EMBARK H&H HOMES

APPROVED
Limited building only review
Permit holder responsible for full compliance with the code

EMBARK (GARAGE RIGHT)
 H&H HOMES

SHEET
 CS

MAIN FLOOR PLAN
 SCALE: 1/4" = 1'-0"

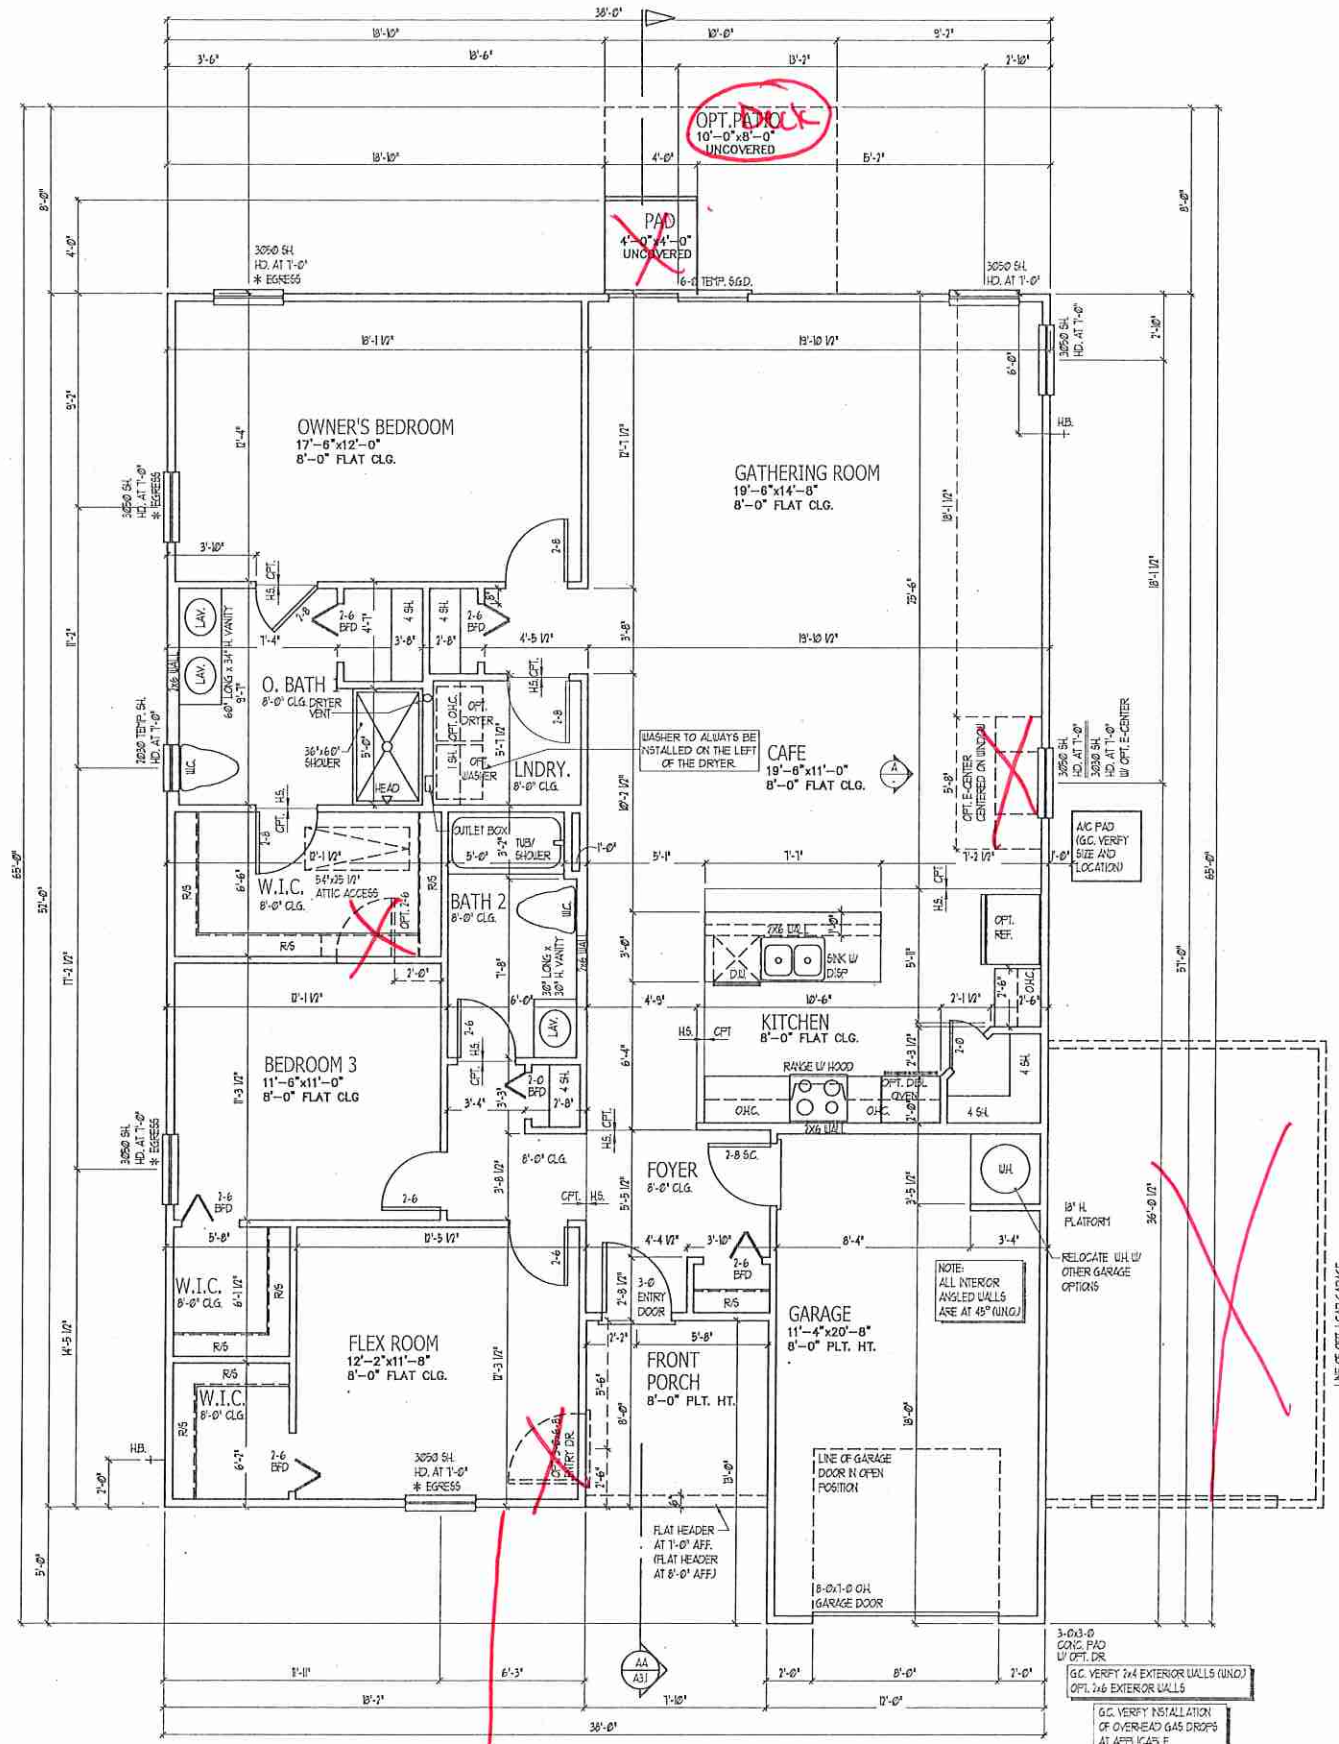
See Elevation B for windows

SHEET 1 OF 10
 S-1.1a
 CRAWL FOUNDATION PLAN

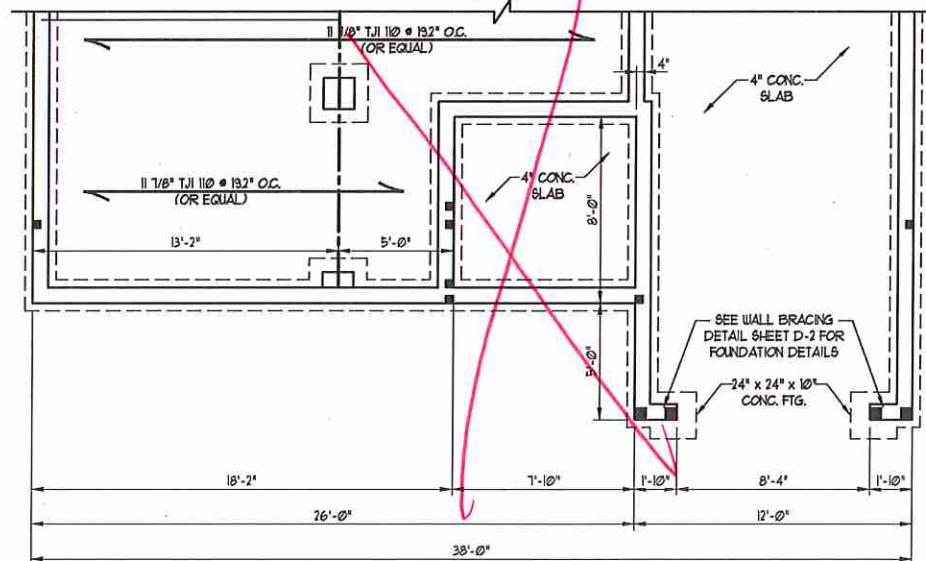
ELEVATION A
 See elev B

ELEVATION A
30'-0" SIDE 1A RECTANGLE A

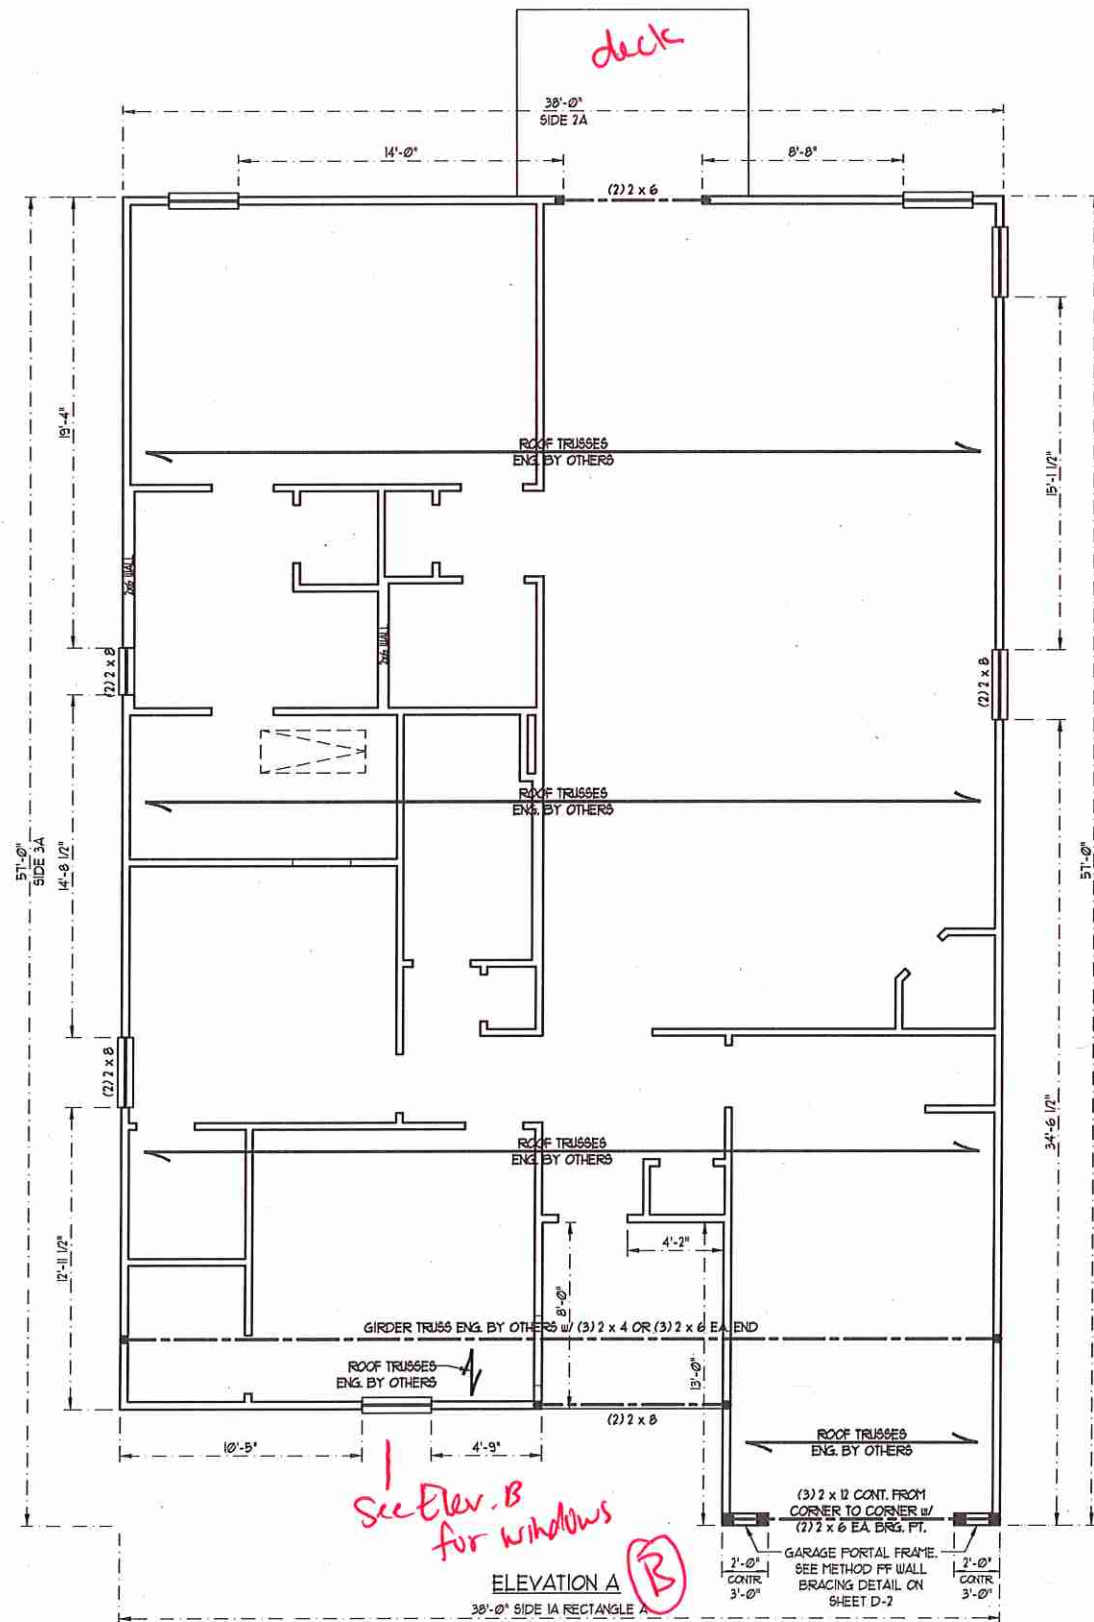
See Elev. B for windows
